Informal Document GRPE-82-10

Proposal for Supplement 1 to the original version of UN Regulation No. 154

Submitted by the representatives of the European Commission and Japan^{*},^{}**

"Figure 8/1

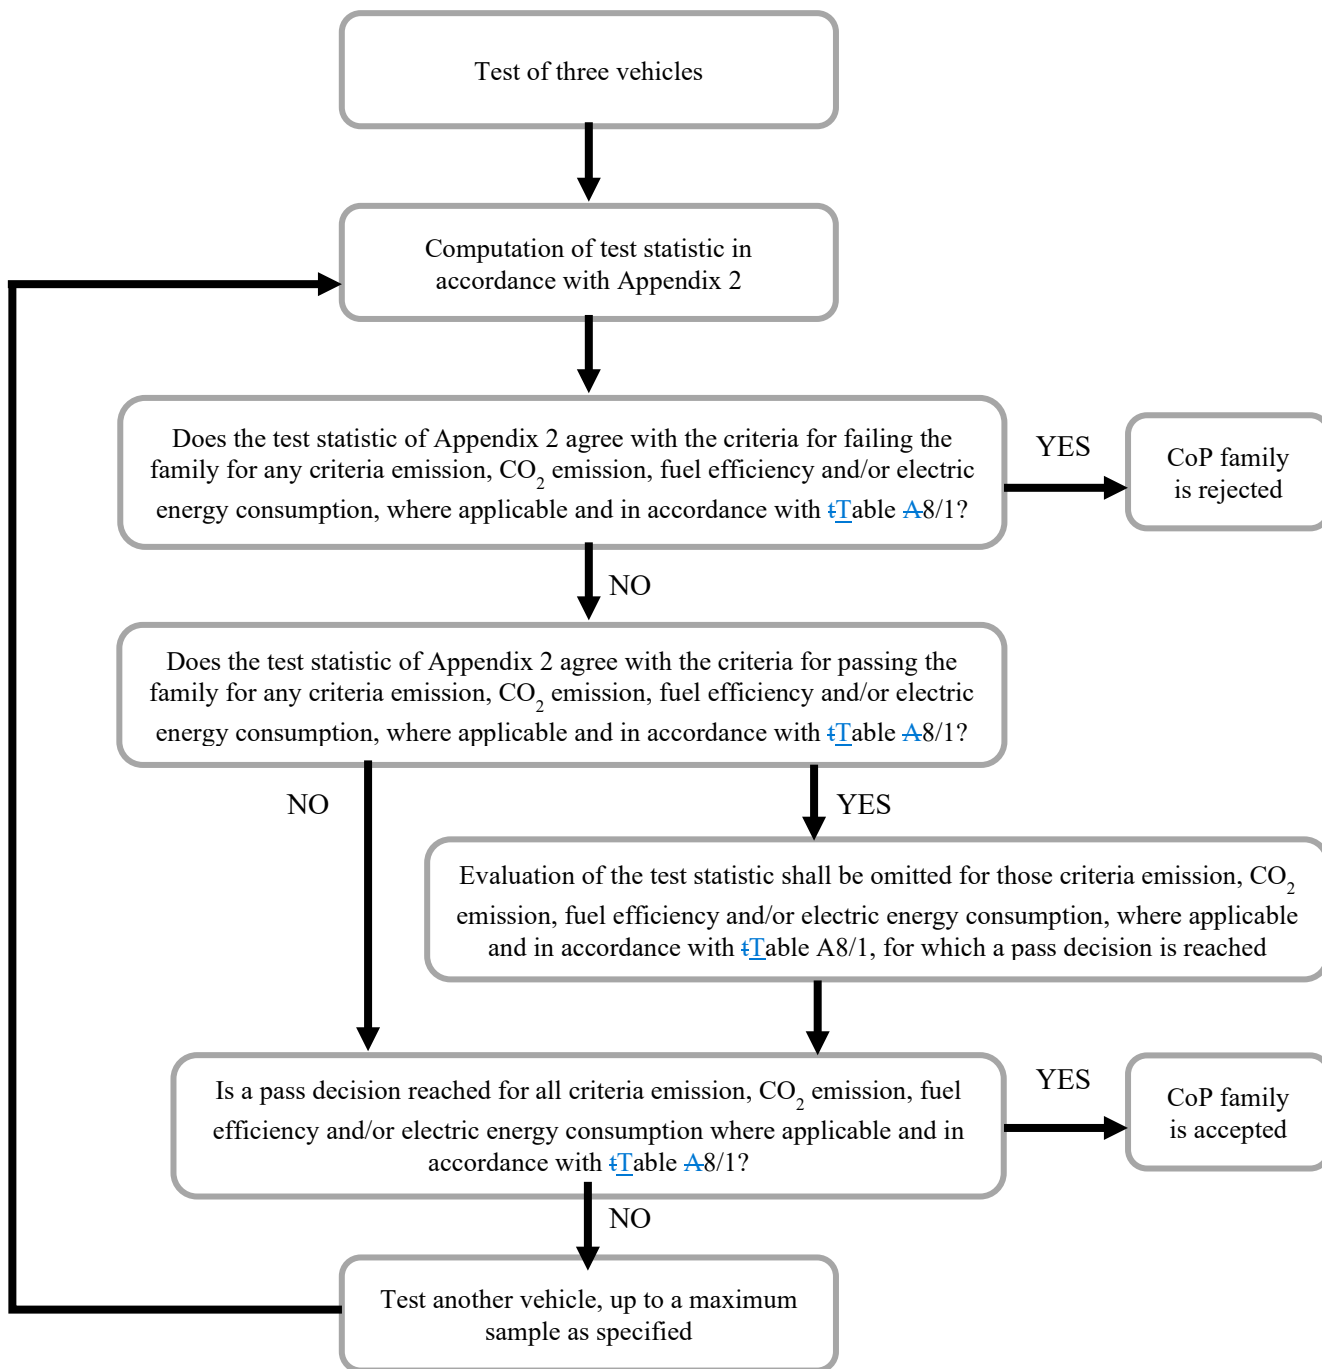
Paragraph 8.2.3.2., Figure 8/1, amend to read:

Figure A6/4

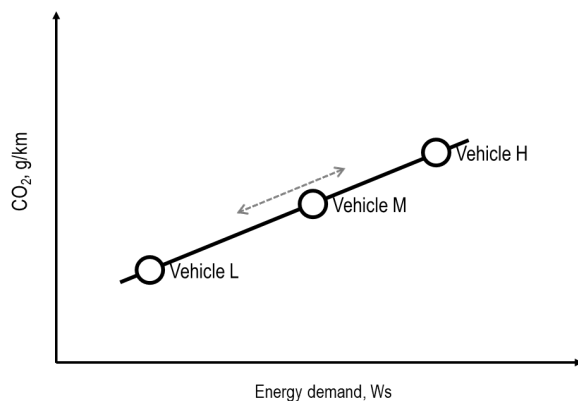
Paragraph 2.3.2.4., amend to read:

The limits of the selection of vehicle M (see Figure A6/4) are such that neither the difference in CO₂ emission values between vehicles H and M nor the difference in CO₂ emission values between vehicles M and L is greater than the allowed CO₂ range in accordance with paragraph 2.3.2.2. of this annex. The defined road load coefficients and the defined test mass shall be recorded.

~~The linearity of CO₂ mass emission for vehicle M shall be verified against the linearly interpolated CO₂ mass emission between vehicles L and H over the applicable cycle by using the corrected measured values referring to the step used in Table A7/1 of Annex B7.~~For Level 1A

The linearity of the corrected measured and averaged CO₂ mass emission for vehicle M, $M_{CO_2,c,6,M}$ according to step 6 of Table A7/1 of Annex B7, shall be verified against the linearly interpolated CO₂ mass emission between vehicles L and H over the applicable cycle by using the corrected measured and averaged CO₂ mass emission $M_{CO_2,c,6,H}$ of vehicle H and $M_{CO_2,c,6,L}$ of vehicle L, according to step 6 of Table A7/1 of Annex B7, for the linear CO₂ mass emission interpolation.

Figure A8/2

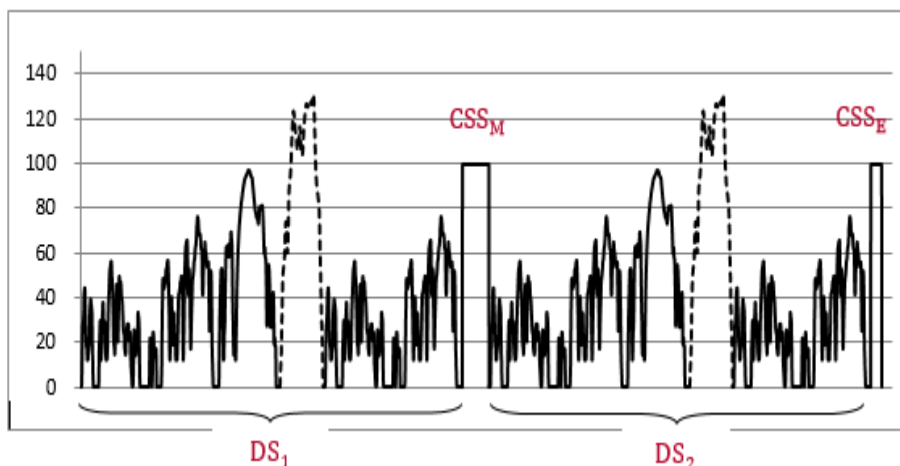
Paragraph 3.4.4.2.1., amend to read:

The shortened Type 1 test procedure consists of two dynamic segments (DS₁ and DS₂) combined with two constant speed segments (CSS_M and CSS_E) as shown in Figure A8/2.

~~The dynamic segments DS₁ and DS₂ are used to calculate the energy consumption of the phase considered, the applicable WLTP city cycle and the applicable WLTP test cycle.~~

~~The constant speed segments CSS_M and CSS_E are intended to reduce test duration by depleting the REESS more rapidly than the consecutive cycle Type 1 test procedure."~~

Figure A8/5

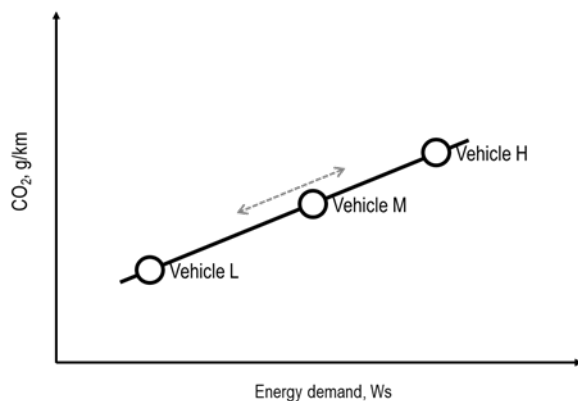
Paragraph 4.5.1.1.5., amend to read:

The limits of the selection of vehicle M (see Figure A8/5) are such that neither the difference in CO₂ mass emission between vehicles H and M nor the difference in charge-sustaining CO₂ mass emission between vehicles M and L is higher than the allowed charge-sustaining CO₂ range according to paragraph 4.5.1.1.2. of this annex. The defined road load coefficients and the defined test mass shall be recorded.

~~The linearity of charge-sustaining CO₂ mass emission for vehicle M shall be verified against the linearly interpolated charge-sustaining CO₂ mass emission between vehicle L and H over the 3-phase and/or 4-phase cycle, as applicable, by using the corrected measured values referring to step 6 $M_{CO_2,cs,e,6}$ of Table A8/5 of this annex. For Level 1A~~

The linearity of the corrected measured and averaged charge-sustaining CO₂ mass emission for vehicle M, $M_{CO_2,c,6,M}$ according to step 6 of Table A8/5 of Annex B8, shall be verified against the linearly interpolated charge-sustaining CO₂ mass emission between vehicles L and H over the applicable cycle by using the corrected measured and averaged charge-sustaining CO₂ mass emission $M_{CO_2,c,6,H}$ of vehicle H and $M_{CO_2,c,6,L}$ of vehicle L, according to step 6 of Table A8/5 of Annex B8, for the linear CO₂ mass emission interpolation.
